REPORT AMENDED BY STAFF 4-13-89
CITY PLANNING COMMISSION

- APPLICATION:
- A. Negative Declaration
 - B. Tentative map to establish two lots for air space condominium development.
 - C. Special Permit to develop 172 condominium units on 13+ vacant acres in the Single Family Alternative (R-1A) Zone.

APPLC. NO. P88-360 MEETING DATE 14 4-13-89 ITEM NO. 49
~~March 23, 1989~~

FRANKLIN VILLAGE
SACRAMENTO, CA.

END ELEVATION at 'C' UNIT

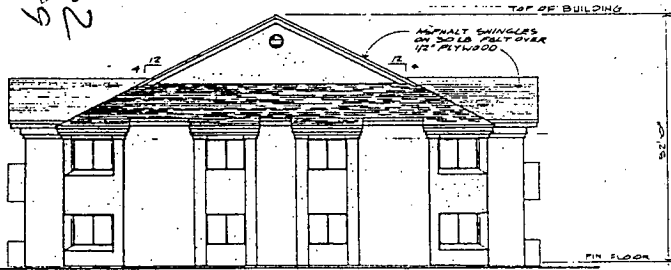
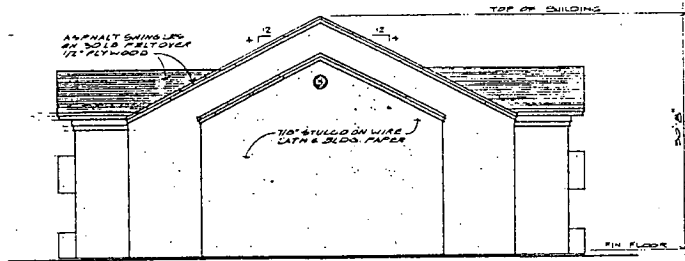
The applicant proposes to construct the condominium structures utilizing stucco with wood trim. Staff notes that the buildings are attractively designed and will be compatible with adjacent residential uses. Staff recommends that a wood shake roofing material be used, subject to Planning Director review and approval. The applicant should also be aware that the height limit in the Garden Apartment zone is 35 feet. The elevations should reflect this height requirement. The end elevations need to be redesigned with window elements.

12. The buildings shall include the following items:
 - a. exterior materials shall include horizontal and/or wood stucco siding with windows or variation on all exterior elevations of the units.

- c. all roofs shall be covered with wood shake, shingle, tile material or heavy butt composition shingle (30 year life) that is approved by the Planning Director.

14. Roof line on two story buildings shall be broken up and not a continuous line.
 15. Each lot shall have a minimum of one garage per unit and adequate outdoor vehicle parking based upon the Multiple Family Design Guidelines. (Exhibit A)
